Olympus reference: QIL FY25-EMEA-28-FY25-013 Guide Sheath Component**URGENT: FIELD SAFETY NOTICE****RE: Single Use Guide Sheath Kit****Attention:** Endoscopy Department, Bronchoscopy Suite, Pulmonology, Risk Management

Olympus is writing to inform you of a Field Corrective Action pertaining to the Single Use Guide Sheath Kits, models K-201, K-202, K-203, and K-204. These instruments have been designed to be used with an Olympus endoscope to collect cells or tissue specimens in the respiratory organs.

Figure 1: Single Use Guide Sheath (models SG-200C and SG-201C)

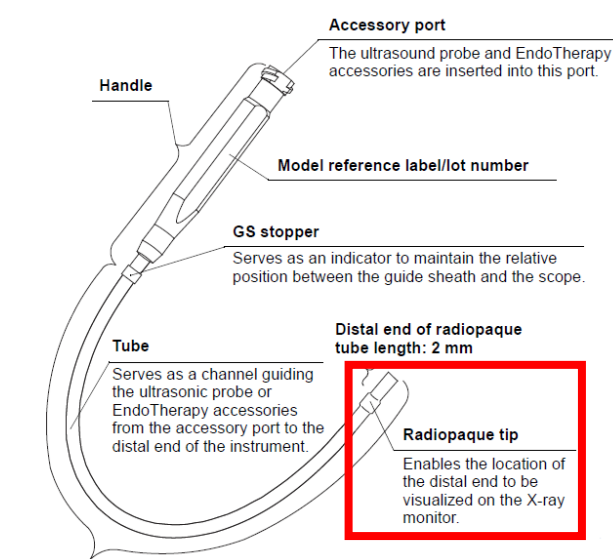
Olympus conducted an investigation into the Single Use Guide Sheath Kits after receiving complaints that the radiopaque tip of the guide sheath component (see Figure 1 below), fell off into the patient. Since July 2021, Olympus has received 32 complaints involving intraoperative disassociation of the guide sheath radiopaque tip in which the tip fell off into the patient. Of these 32 complaints, 26 were reported as serious injuries, and 6 were reported as malfunctions. The preliminary findings from Olympus' investigation have identified that the disassociation of the tip from the guide sheath is likely the result of excessive force applied when inserting instruments into the guide sheath, and/or damage to the distal end of the sheath.

Olympus has launched the next generation of the Single Use Guide Sheath Kits, models K-401, K-402, K-403, and K-404, which has a different radiopaque tip design. Therefore, Olympus has discontinued the previous generation models (K-201, K-202, K-203, and K-204) and is removing these models from the market.

You should stop using the K-201, K-202, K-203, and K-204 Single Use Guide Sheath Kits as soon as possible. The next generation Single Use Guide Sheath Kits, models K-401, K-402, K-403, and K-404, should be used by your facility instead.

1. Examine your inventory for Single Use Guide Sheath Kits, models K-201, K-202, K-203, and K-204, and quarantine these devices.
2. **Cease usage of the product with immediate effect.**
3. If you have affected products in your inventory, please contact Olympus at [XXXXX](#). Olympus will issue a credit to your facility upon return of your affected product.
4. Olympus requests that you acknowledge receipt of this letter by completing and returning the enclosed Reply Form to your local Olympus representative [\[local facility method/contact\]](#) by [\[X date\]](#).
5. Please forward this notice to other users who may have the affected products if you have further distributed it.
